PRODUCT INFORMATION

PTO PI2203.0_GB

MATERIAL CHANGE INNER GUARD-FLEXO 675

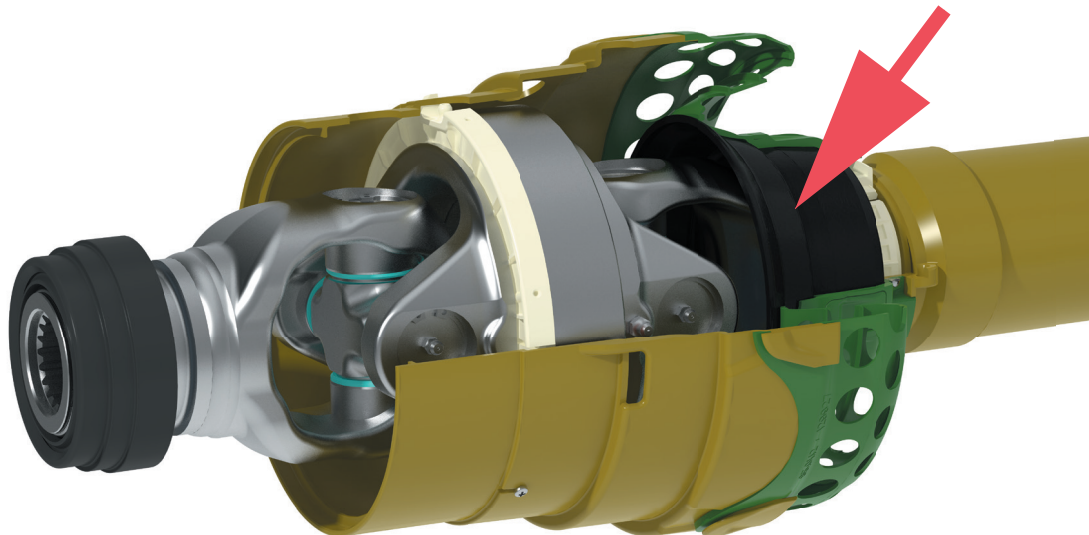
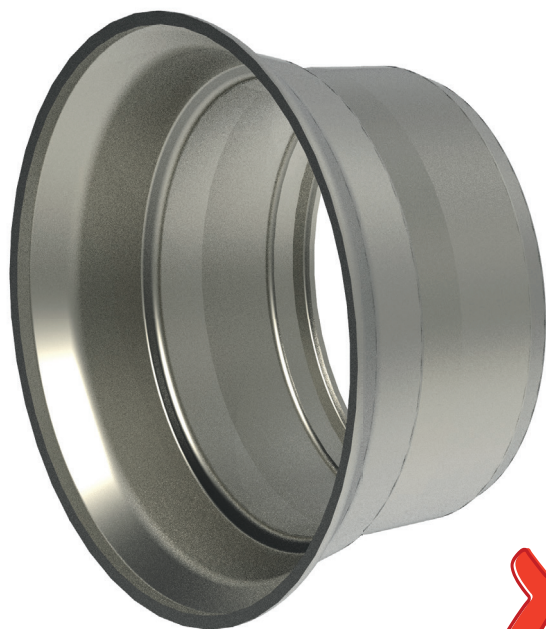
- support of the flexo element in case of articulation
- sheet metal design
- high weight

- constant support function
- fiber reinforced plastic
- weight saving
- slightly optimized geometry
- SNR 696720 / ZNR 16.50.711
